# PRODUCT CHANGE NOTIFICATION

### Bourns® Model CDSOT23-SR208 Steering Diode Array and CDSOT23-SRV05-4 Steering Diode TVS Array Combo *Addition of Manufacturing Site*

ESD2311

#### Typical Part Marking

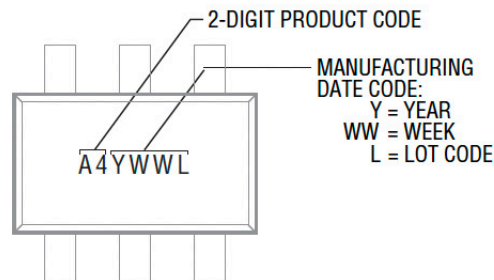
The Si fabrication and the assembly process will not change at this new additional assembly and test manufacturing site. The interconnect material used at this new site will be changed from gold to copper. This change has been fully qualified and will have no impact on the fit or function of the affected part numbers. The part marking will be used to identify units produced at the new additional assembly and test manufacturing site. The lot code (L) of the new site will follow alphabetic characters while the current site will continue to use numbers.

The form of the part numbers made at the new additional manufacturing site will change because of a small change in the part marking for traceability purposes. The quality, reliability and performance of the overvoltage protectors produced at the new manufacturing site will be the same as those from the existing plant. The production lead times of these overvoltage protectors should improve gradually as our capacity is expanded. The country of origin will remain the same.
